[Docket No. 97-SW-60-AD]

Airworthiness Directives; Sikorsky Aircraft-Manufactured Model CH-54A Helicopters

ACTION: Notice of proposed rulemaking (NPRM).

Rework of Second Stage
Lower Planetary Plate (6435-20229-102)
Figure 1

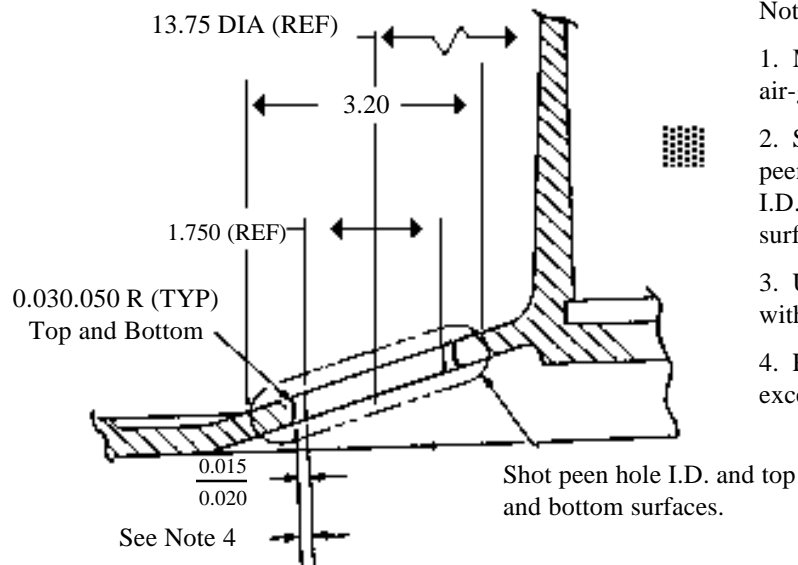
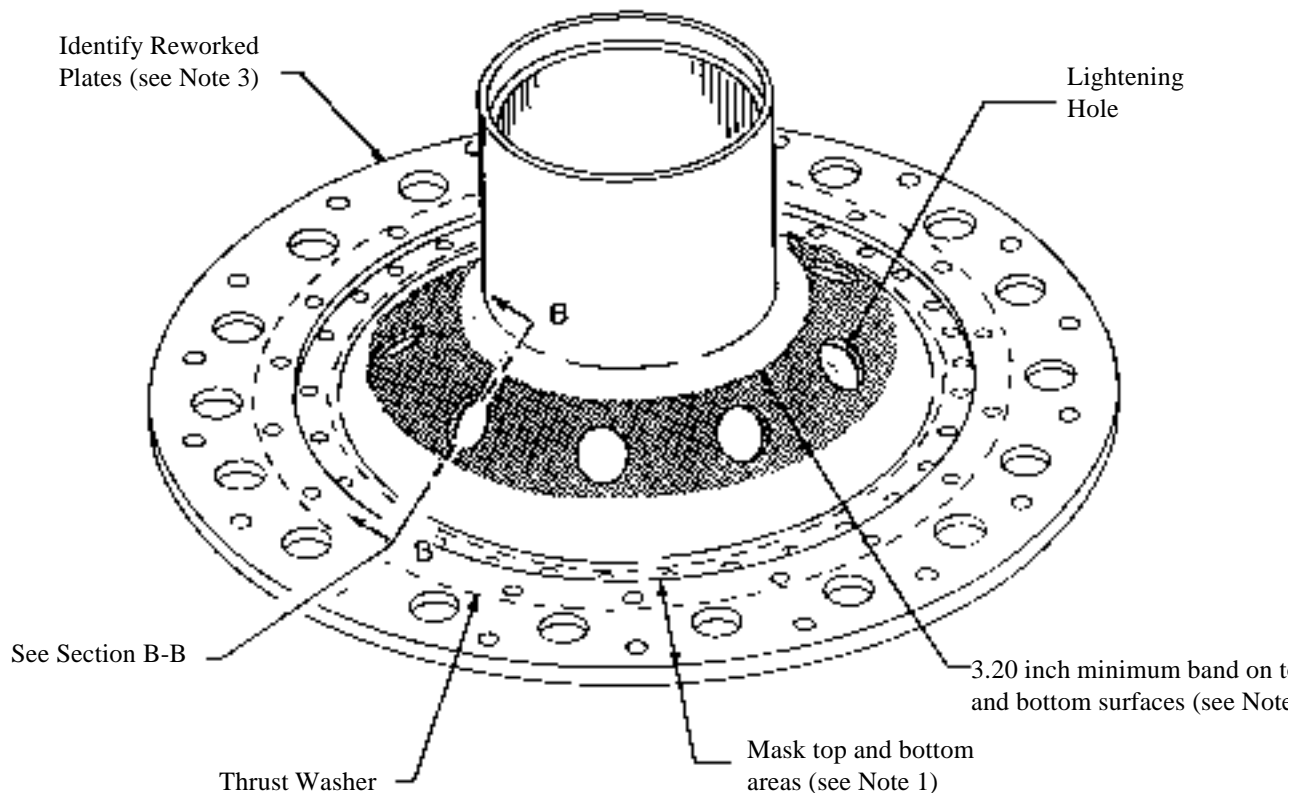
(i) Locate the center of each 1.750 inch-diameter lightning hole and machine holes 0.015 to 0.020 oversize on a side (0.030 to 0.040 diameter oversize). Machined surface roughness must not exceed 63 microinches AA rating (see Figure 1).

(ii) Radius each hole 0.030 to 0.050 inches on each edge as shown in Figure 1.

(iii) Mask the top and bottom surfaces of the plate to expose 3.20 inch minimum width circumferential band as shown in Figure 1.

(viii) Identify the reworked plate by adding “TS-107” after the part number using a low-stress depth-controlled impression-stamp with a full fillet depth of not more than 0.003 inch (see Figure 1).

Borescope Inspection of
Second Stage Lower Planetary Plate
Figure 2

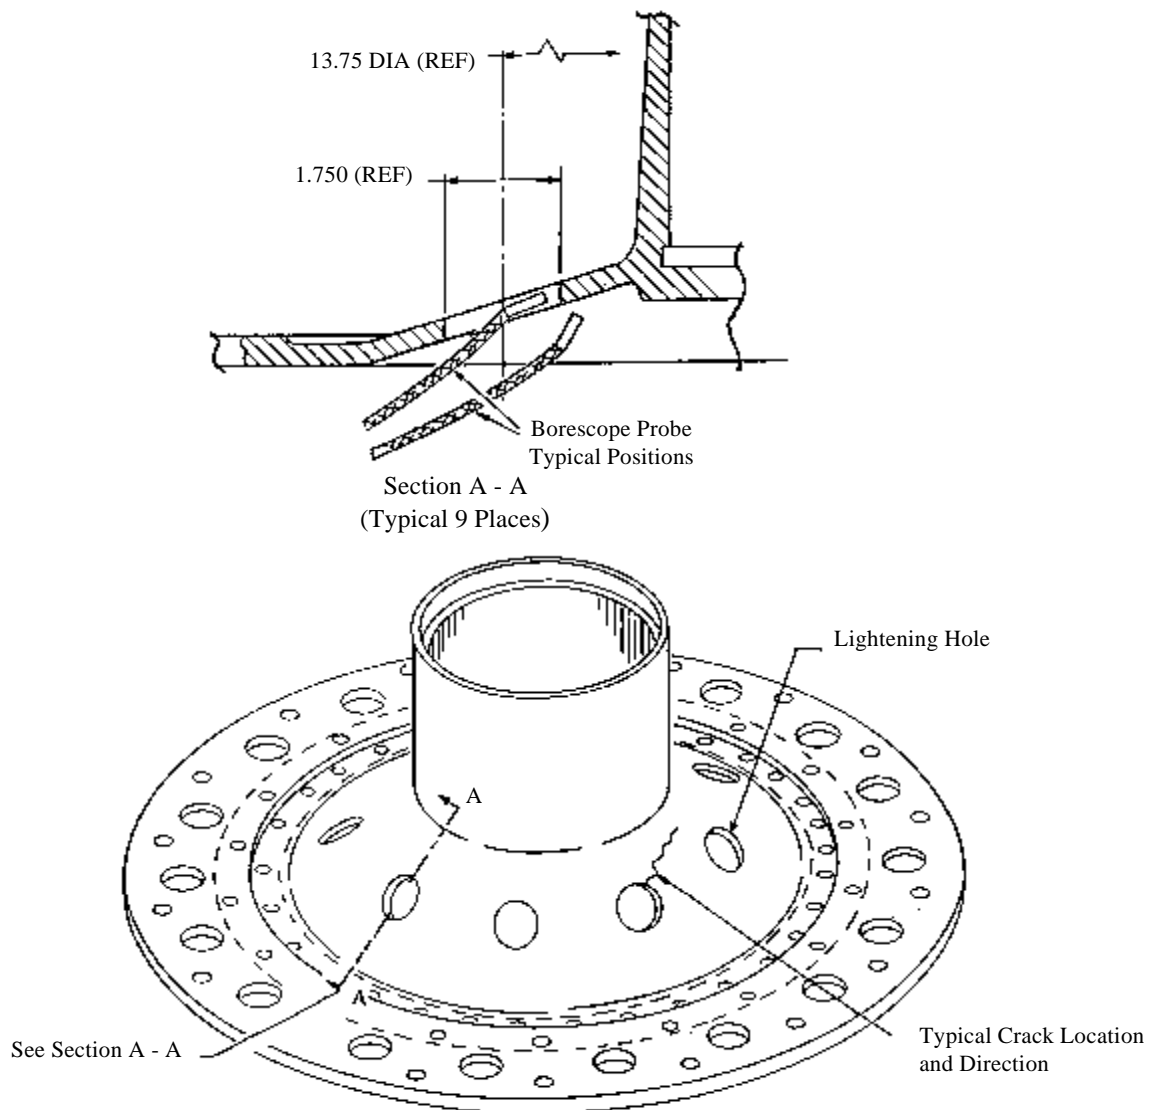
(1) Inspect the plate for a crack in the area around all nine lightening holes using a Borescope or equivalent inspection method (see Figure 2).

(2) If a crack is found, replace the plate with an airworthy plate.
